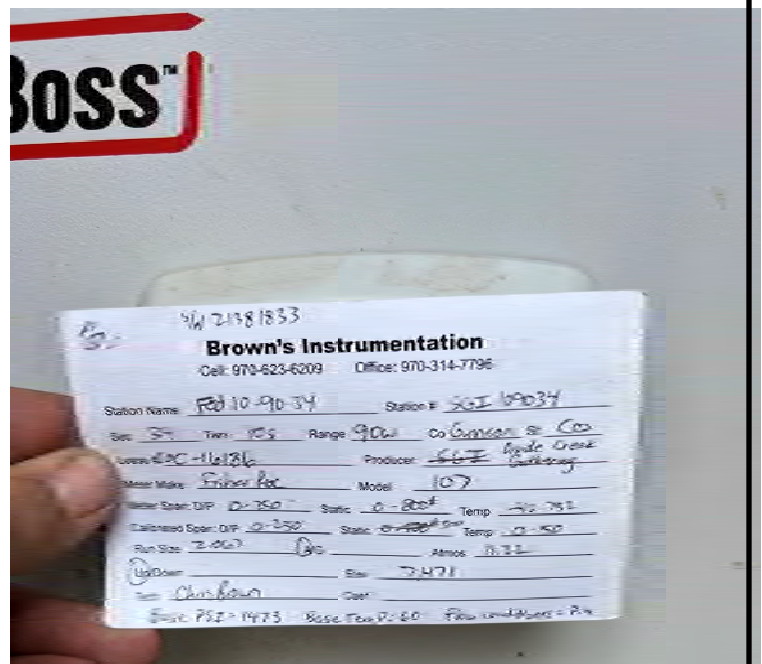
CA 2 of 4 - Unknown fluid (water) accumulating around bradenhead.  
Water removed
